**Amendments to the Drawing Figures:**

**REMARKS**

**Fig. 3**

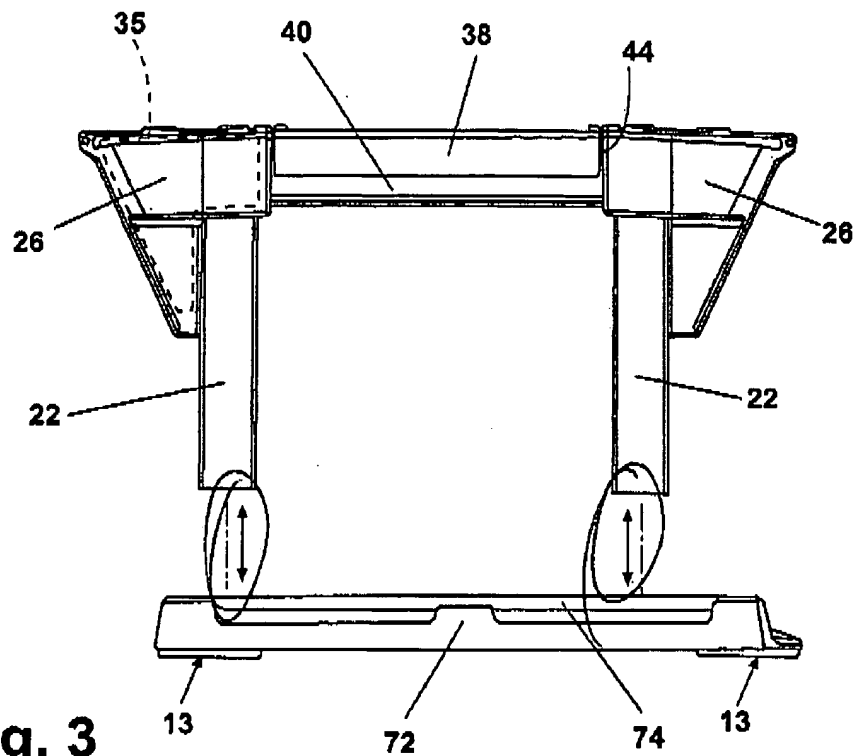
The drawings were objected to because they failed to show the electrical socket was attached to a power supply of the vehicle, and that the framework assembly could be removed from the base assembly as claimed and described in the patent specification.

The drawing figures have been amended to reflect that the upright support assemblies properly identified by reference numeral 22 may be attached to the base tray assembly 18 in a first configuration and removed from the base tray assembly in a second configuration as recited in independent claim 1. Language of similar import is contained within independent claims 11, 14, 16, and 25.

A set of drawing figures showing the proposed changes are attached with the proposed change enclosed within the circled regions.

The drawings have been amended as illustrated by the annotations accompanying this response. Moreover this issue has also been addressed by amending certain of the claims to
